STAFF RECOMMENDATION

1511 Gartland Avenue

January 20, 2021

Figure 2: The outbuilding was installed at the edge of the property line with no setback.

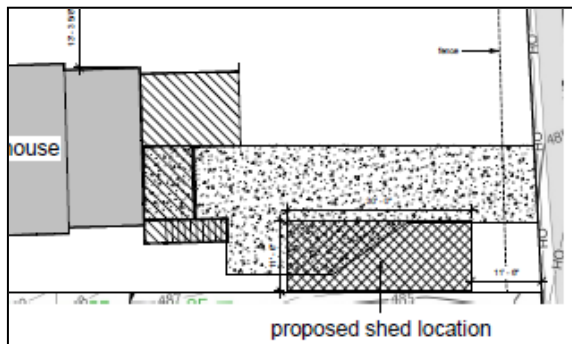
Location: As installed, the outbuilding sits on the right-side property line, and eleven feet, six inches (11' 6") from the rear property line. With no garage doors facing the alley, the outbuilding meets the rear setback. However, the structure does not meet the setback requirements on the right-side, where a minimum of three feet (3') is required.

Staff finds the project does not meet section II.B.8. (b) for location.

Staff recommends disapproval, finding the project does not meet section II.B.8 for Outbuildings of the Lockeland Springs-East End Neighborhood Conservation Zoning Overlay and recommends that the building be removed from the site within sixty (60) days.
